3. HP Memo - 582-584 Congress Street

**LEGAL ADVERTISEMENT
HISTORIC PRESERVATION BOARD
CITY OF PORTLAND**

- i. Certificate of Appropriateness for Storefront Alterations (front & rear elevations) and Roof Deck Construction; 582-584 CONGRESS (Rear Elevations, 143-145 FREE STREET); Corner Freak LLC., Applicant

S-2.1

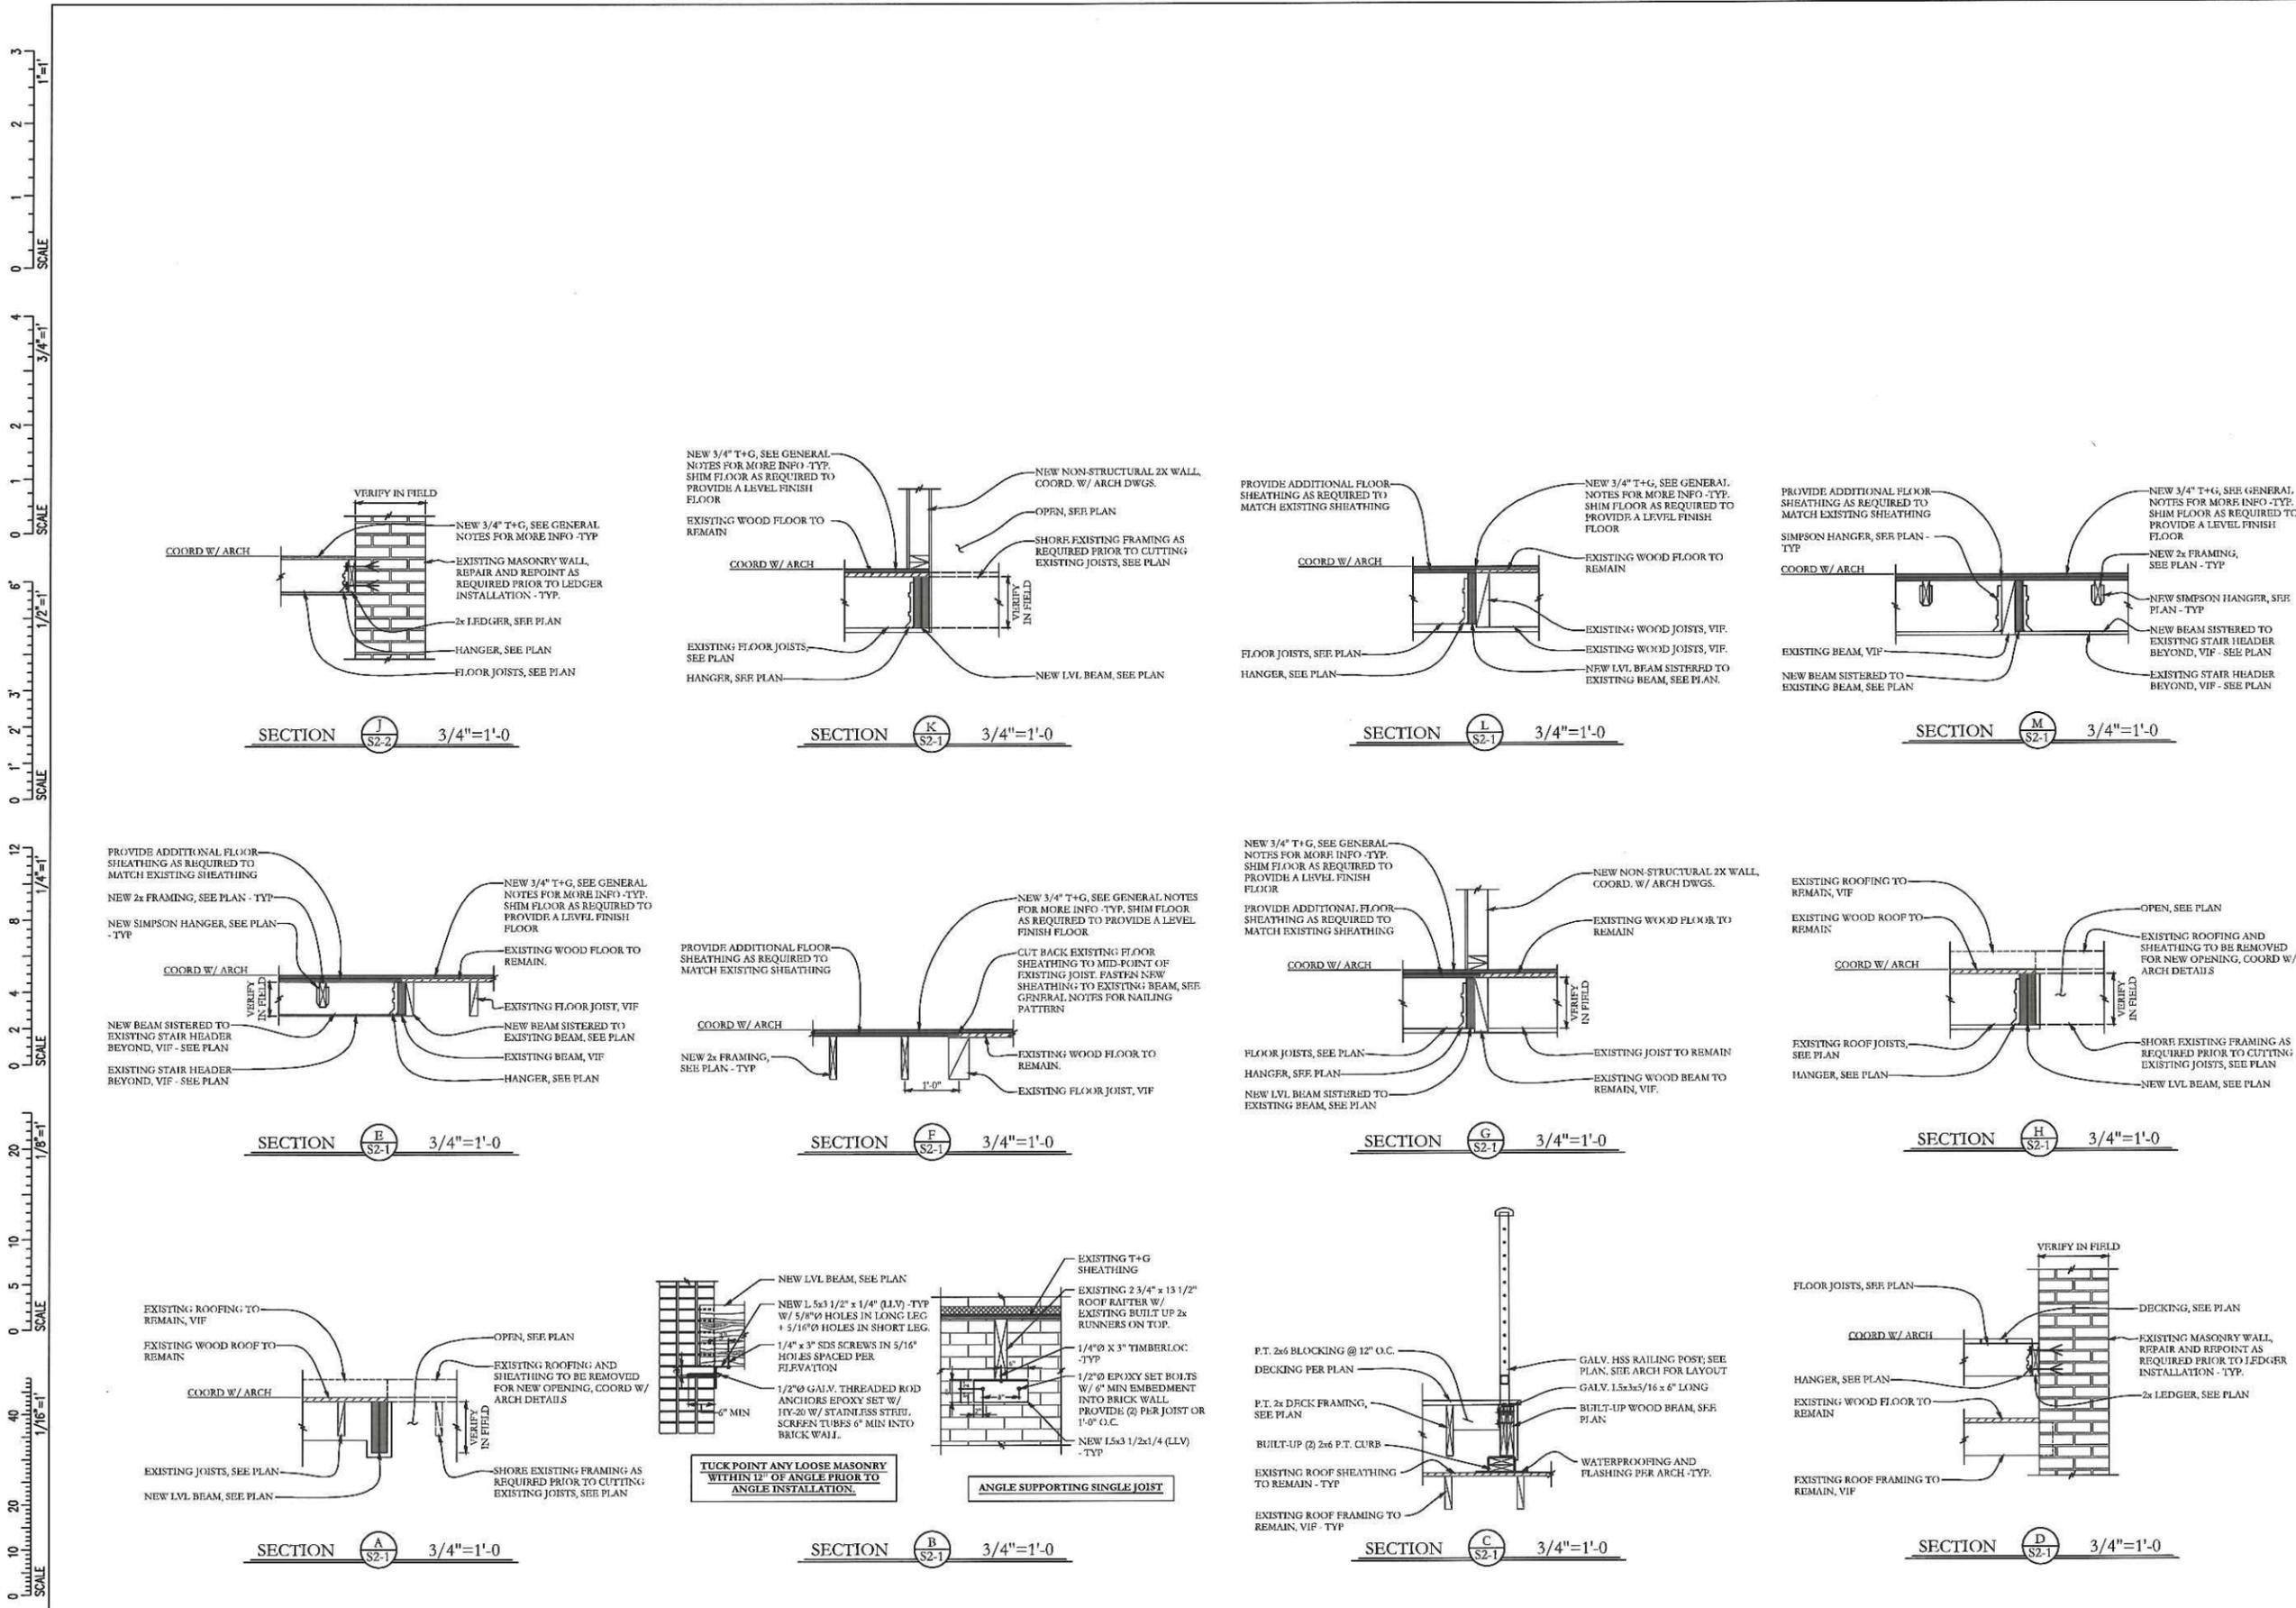
At 584 Congress (Unit B) the deck planned for the rooftop is set back at least 11' from the closest edge of the Congress Street roof edge, and more than 6' away from the Free Street edge. According to Mr. Ungs, the deck is to be as low to the roof as possible – perhaps 12" to 14" above the roof surface. (See structural detail, Sheet S-2.1)

582 Congress Free Street Side

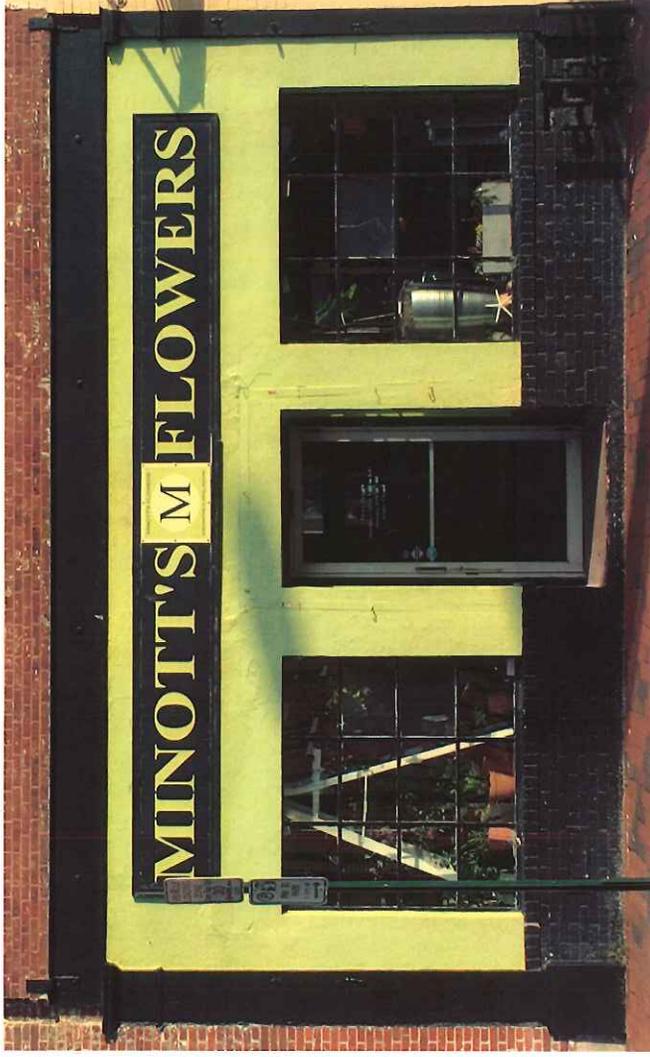
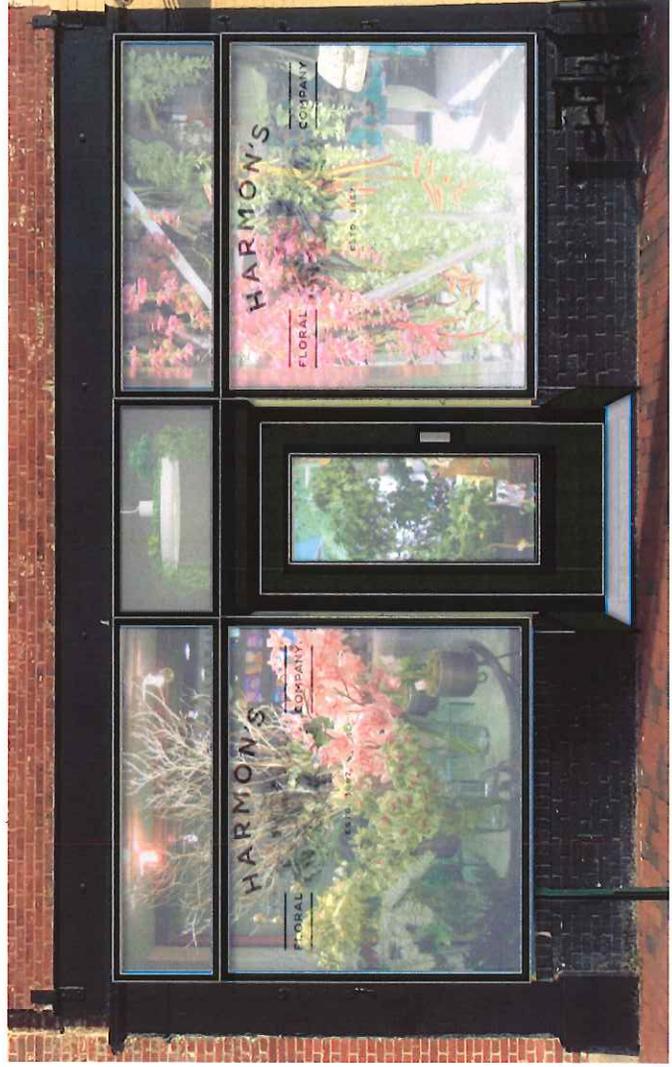
Staff believes the Board could help provide the applicant with direction regarding some aspects of the proposed new storefront at the rear of 584 Congress Street (147 Free Street.)
